Access Compliance Report

Public Rights-of-Way

(Curb Ramps)

Intersection ID: 12958	Main Street: E_3RD_ST	Cross Street: S_DAVIDSON_ST	Location: N
ADA ID: C8B8A2D519BF	Ramp Type: PerpDiag	Initial Pass/Fail: Pass	Overall Compliance: No
Severity Score: 0.25			
Codes/Mitigation Info/Possible Solution		Field Measurements/Component Compliance

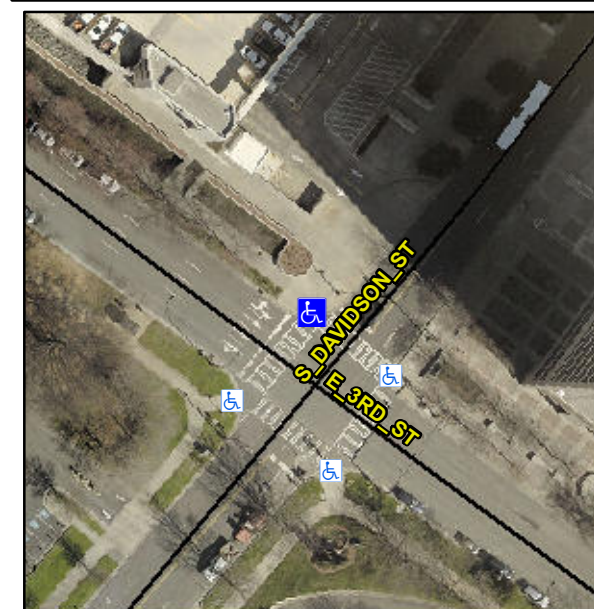
Not Found, R305.2

Compliance	Description	Data	Compliance	Description	Data
N/A	Ramp Length (in)	72.0	Yes	Ramp Slope (%)	4.9
Yes	Ramp Width (in)	48.0	Yes	Ramp XSlope (%)	3.2
N/A	Flare Type LT	Sloped	N/A	Flare Type RT	N/A
N/A	Flare Slope LT (%)	8.2	Yes	Flare Slope RT (%)	3.2
N/A	Flare Traversable LT?	Yes	N/A	Flare Traversable RT?	Yes
Yes	Landing Length (in)	48.0	Yes	DWS Provided?	Yes
Yes	Landing Width (in)	48.0	Yes	DWS Contrast?	Yes
Yes	Landing Slope (%)	1.7	Yes	DWS Length (in)	24.0
Yes	Landing X Slope (%)	3.2	Yes	DWS Full Width?	Yes
N/A	Landing Curb? (Y/N)	No	No	DWS Offset (in)	5.0
N/A	Shared Landing?	No			
Yes	Gutter Ponding?	No	Yes	Gutter Slope (%)	1.2
Yes	Gutter Lip Ht (in)	0.0	Yes	Gutter X Slope (%)	1.9
N/A	Painted X Walk1?	Yes	N/A	Painted X Walk2?	Yes
	X Walk 1 Direction	To SW		X Walk 2 Direction	To SE
N/A	X Walk 1 Width (in)	118.0	N/A	X Walk 2 Width (in)	110.0
	X Walk 1 Slope (%)	3.6		X Walk 2 Slope (%)	0.9
	X Walk 1 X Slope (%)	0.3		X Walk 2 X Slope (%)	3.6

Yes	Ramp inside XWalk1?	Yes	Yes	Ramp inside XWalk2?	Yes
	Road Slope (%)	4.4	N/A	Clear Space?	Yes
	Road X Slope (%)	2.6	Yes	Clear Space to XWalk (in)	68.0
Yes	Any Obstructions?	No	Yes	Storm Grate/Utility Hazard?	No
	Obstruction Type			Storm Grate/Utility Type	
		N/A			N/A
		Yes		Surface Condition? (G/P)	Good

Remove & Replace Curb Ramp With Two New Directional Ramps or Equivalent.
